ISSUE: Permit to Demolish/Capsulate (partial) and Certificate of Appropriateness for (alterations, addition)

APPLICANT: Christopher & Sarah Miller

LOCATION: Old and Historic Alexandria District
826 South Lee Street

Minutes from June 1, 2022 BAR Hearing:

Figure 1: Proposed demolition at east elevation

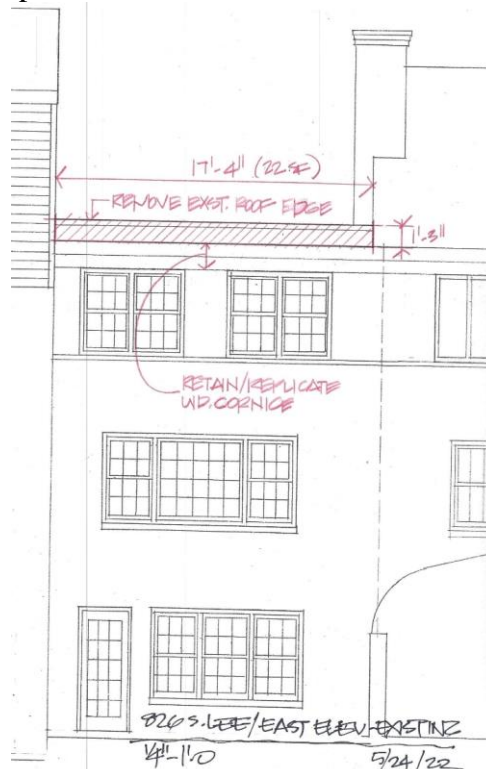
In the opinion of staff, none of the criteria for demolition and capsulation are met and the Permit to Demolish/Capsulate should be granted. Due to the height of the existing parapet the roof is not visible from South Lee Street and while it may be minimally visible from the park to the east, it is not considered to be a character defining feature. Per Board comments at the previous hearing, the existing parapet will no longer be demolished, leaving the existing façade intact. The existing shutters do not appear to be original to the building and do not meet the requirements of the *Design Guidelines*. Staff therefore does not object to the proposed demolition/capsulation. See Figure 1 below for the extent of the proposed demolition.

Figure 2: Section at proposed third floor addition

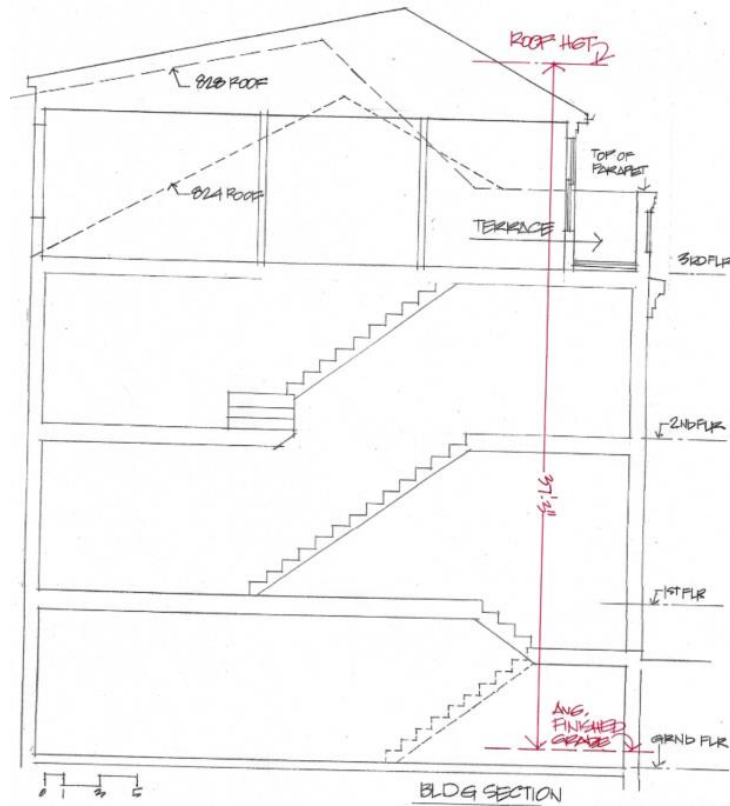
As noted above, at the last hearing the Board expressed concern regarding the elimination of the existing parapet and extension of the new side gable roof to the front elevation of the structure. The Board noted that the parapet with the recessed brick panels is an important character defining element for the building and is an important part of the rhythm of the overall blockface. The Board also noted that the proposed asymmetrical dormer appeared to be inconsistent with the design of the building and while the structure immediately to the south of the property features a similar dormer, that dormer is not particularly successful.

The applicant has revised the design for the third floor addition in response to these comments. In the revised design, the existing parapet and recessed brick panels remain in place with the west wall of the addition pushed back from the back side of the parapet wall by a dimension of 3'-6". This will create a roof terrace along the front edge of the building that will drain through the new roof scuppers into the new gutter and downspout. The asymmetrical side gable roof form will start at this point with the front portion of the roof having a slope that is similar to the front roof slope at 824 South Lee Street and the rear portion having a lower roof slope to allow for useable space within the rear section of the addition (Figure 2).

The west elevation of the addition will be clad in smooth PVC panels and have three casement style punched windows that align with the existing windows below. The use of smooth PVC panels in this location will differentiate this as a clearly modern addition to the existing building while allowing it to be a quiet background to the more decorative brick below. According to the *Design Guidelines*, “An addition to a historic building should be clearly distinguishable from the original structure. An addition should not obscure or dilute the architectural and historic importance of an existing building by creating a false sense of the past. To create a differentiation between the existing building and an addition, different traditional materials can be utilized.” The roof visible from South Lee Street will be reminiscent of the adjacent roofs, allowing the addition to be compatible with the adjacent structures without trying to replicate them. The trim at the addition will be a smooth PVC to match the panels and will be simple in design including a fascia, corner boards, and simple window trim (Figure 3).

Figure 4: Site section showing line of site from South Lee Street

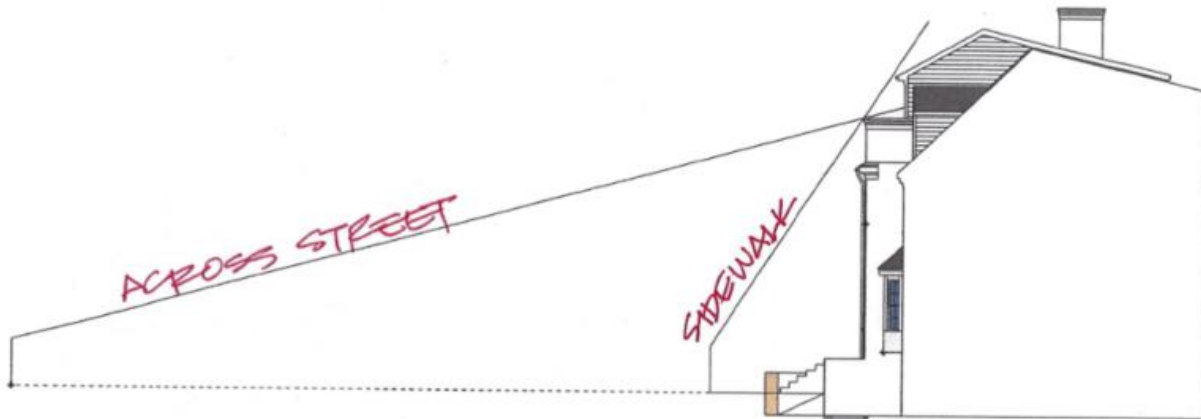
As noted above, the west elevation of the proposed addition will be set back from the existing parapet by 3'-6". This allows the existing parapet to remain in place, preserving the original rhythm of the blockface. It also diminishes the visibility of the addition when viewed from the adjacent South Lee Street (Figure 4). Along with the simple design for this elevation, the proposed massing renders the addition as a secondary element to the existing building (Figure 5). The proposed roof slope does result in this property being taller than other adjacent buildings. Staff recommends that the applicant work with staff to refine the roof slope to minimize the height to the greatest extent possible.

1. The windows comply with the *Alexandria New and Replacement Window Performance Specifications in the Historic Districts*
2. The applicant work with staff on the final configuration of the proposed roof.

Figure 6: Proposed east elevation

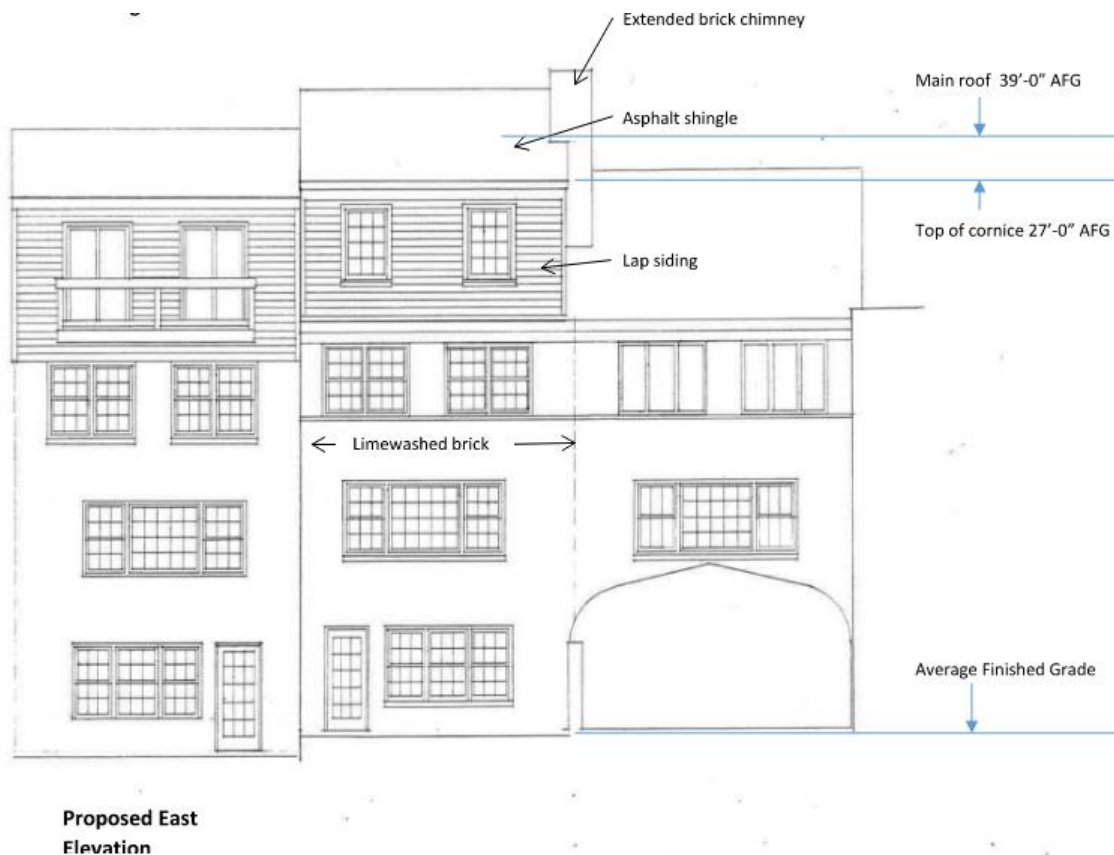
The applicant is proposing an asymmetrical gable roof configuration with the front slope meant to be similar and complementary to other roofs in the vicinity. The use of a lower slope roof for the rear part of the structure allows for the creation of usable space that is shifted away from the primary elevation. At the east elevation, this creates a vertical addition to the existing wall. The applicant is proposing to clad this addition in fiber cement siding and use two simple casement style windows centered on windows below. The east side of the building is clearly a secondary elevation and only visible from the public park and not a street or sidewalk. The use of fiber cement on the east elevation of the addition clearly distinguishes it from the existing building while taking design cues such as the window spacing from the existing building. Figure 6 below shows the proposed west elevation, this has not changed since the previous submission.
